### Delegated officer report for planning application

| <b>Application no.</b>         | 143484/FO/2025                                                                                                                                                 |         |
| <b>Proposal:</b>               | Change of use to restaurant and bar, with ancillary retail and associated storage area (Sui Generis) along with external alterations and outdoor seating area. |         |
| <b>Address:</b>                | Unit 20, Red Bank, Manchester, M4 4HF                                                                                                                          |         |

Proposed Red Bank Elevation  
1:50@A1

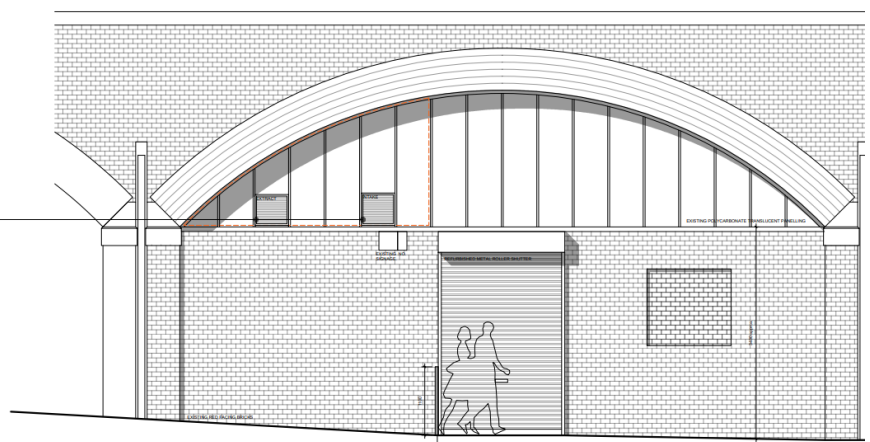
External alterations consist of the installation of 2no. 450mm x 450mm louvres to the Red Bank elevation within the existing glazed upper portion of the archway. These would be rear mounted and colour matched to the mullions, facilitating air and heat exchange.

Location of Ventilation Air Intake / Extraction between existing frame.  
Exact location tbc with specialist subcontractor.

- min.450x450mm Weather Louvre c/w Bird Mesh.
- Anodised Aluminium finish to match existing aluminium frame.
- Rear-mounted concealed fixings - NO VISIBLE FIXINGS.
- Face mounted drip cill to remove water away from facade and prevent staining.

The proposed extraction visible from Red Bank would be colour-matched to the arch mullions and are considered a discrete installation as compared to existing extract systems along the arches.

It is considered sufficiently integrated into the elevation and not to materially alter the appearance of the building. It is noted that similar louvres feature along this elevation in similar positions.

Notwithstanding the details of Condition 2 above, the AC enclosure hereby approved shall be installed in accordance with the correspondence received 03/11/2025 (re: AC enclosure specification and colour); and the 2no. air intake/extraction louvres shall be installed in accordance with the Proposed Elevations (Drawing reference: PR022\_UKIYO\_PL004 Rev C) drawing.
